NEW COUNTRY CLUB ESTATES SUBDIVISION, UNIT 4, A RESURVEY OF LOT 8

APPLICATION NUMBER 6 DATE September 6, 2018
 APPLICANT New Country Club Estates Subdivision, Unit 4, A Resurvey of Lot 8
 REQUEST Subdivision

DETAIL SITE PLAN

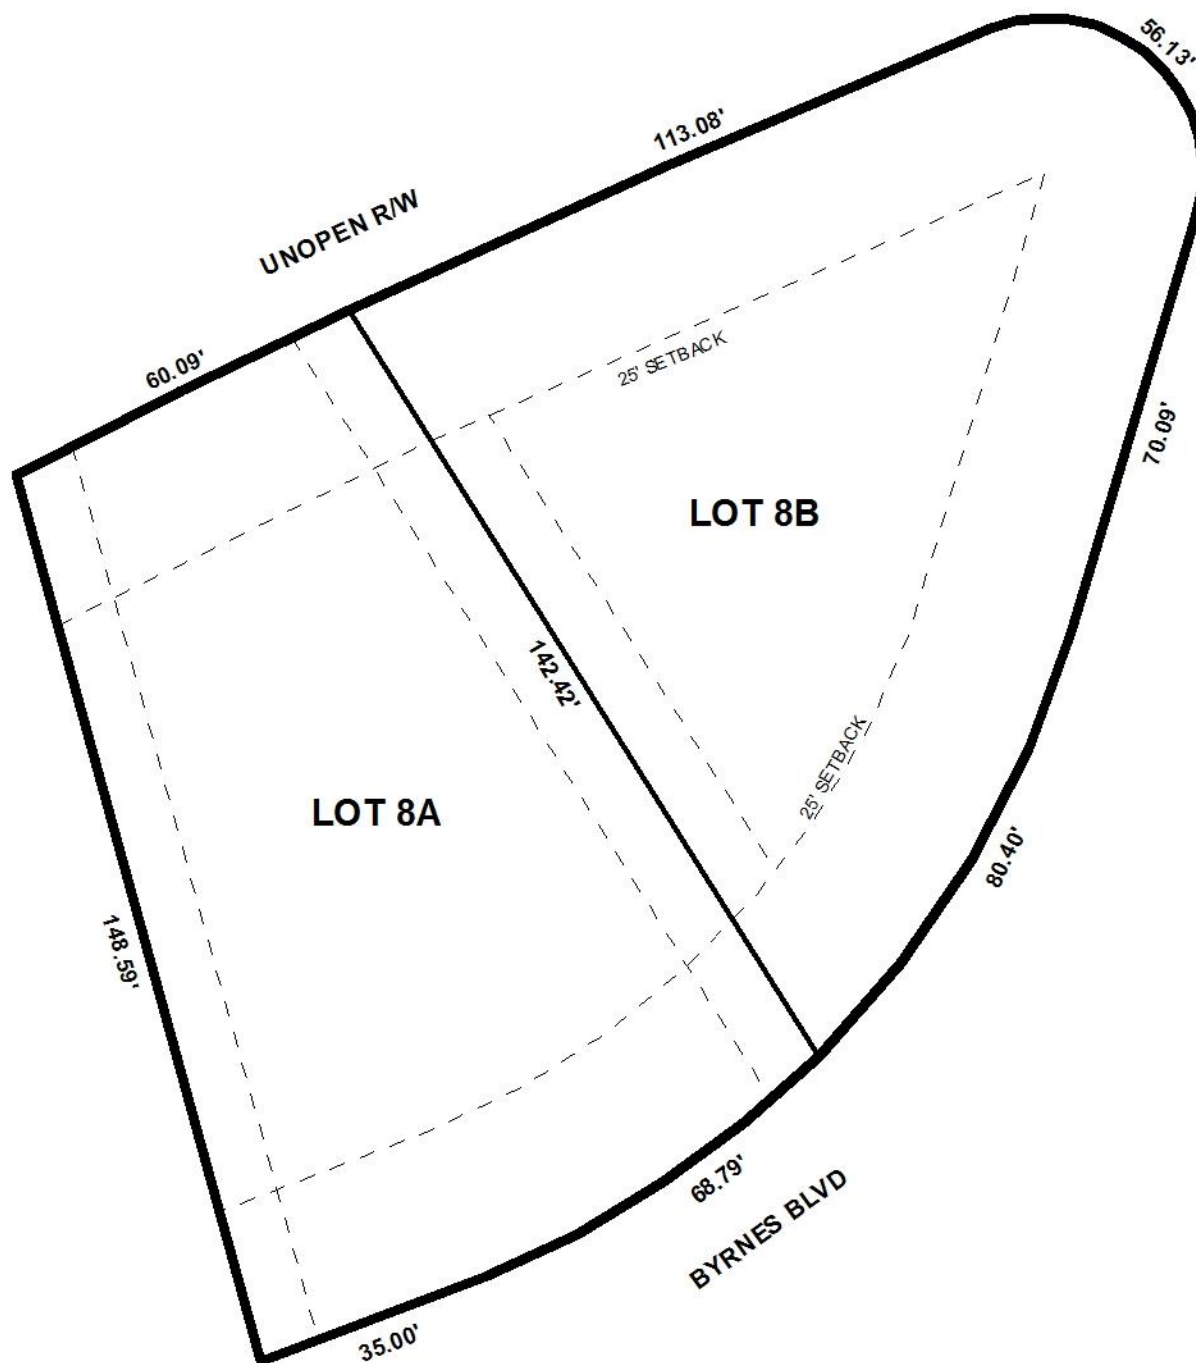
Major Street Plan when it was revised in May 2017. Byrnes Boulevard is a minor street with ribbon curb and gutter thus requiring a 50' right-of-way. It appears that adequate right-of-way may be provided, however the plat must be revised to depict the minimum right-of-way widths for both Byrnes Boulevard and the unopened right-of-way.

The lot sizes are depicted in square feet, but not in acres. If approved, the plat should be revised to depict both lots in square feet and acres or the provision of a chart depicting that information will be required.

The 25' minimum building setback lines are depicted from all rights-of-way. As the unopened right-of-way is no longer needed for a proposed street, the Planning Commission may wish to consider waiving the 25' setback along this right-of-way to allow a standard 8' rear yard setback.

- 1) revision of the plat to depict the right-of-way widths for both Byrnes Boulevard and the unopened right-of-way;
- 2) revision of the plat to depict the lot sizes in square feet and acres or the provision of a chart depicting that information;

- 3) retention of the 25' minimum building setback line on the Final Plat only along Byrnes Boulevard;
- 4) placement of a note on the Final Plat stating that each lot is limited to one curb-cut each with size, location and design to be approved by Traffic Engineering, and conform to AASHTO standards;
